Product Change Notification (PCN)

PCN Number	505366	Date Issued	April 17, 2018
Reason for Change	Change to Product		
Change Type Description	This letter is to inform you that changes are being made to the part(s) identified in this Notice. The change may affect the fit, form, function or appearance of the parts, or it may result in a change to the specification. The pictures below show an example of the possible differences.		
Assessment of Change	Product will be fully qualified before it is shipped. Qualification reports are available upon request.		
Internal Molex Qualification Date	April 30, 2018		
Sample Availability Date (Changed Part)	April 30, 2018		
Planned Implementation Date	October 17, 2018		
Method of Identifying Change	Lot information on label

Molex Part #
349674001

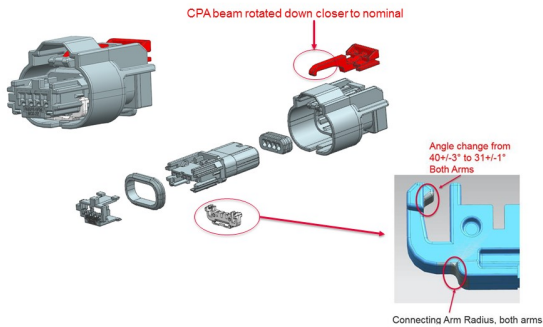
- Change angle and add the connecting arm radius of ISL and rotate beam of CPA for mini50 sealed connectors
- Product Impact
 - Improve the ISL and CPA disengage performance.
 - no other impact to fit, form or function
- Part Number Impact
 - see attached impacted parts list
- Qualification Reports and samples available upon request.
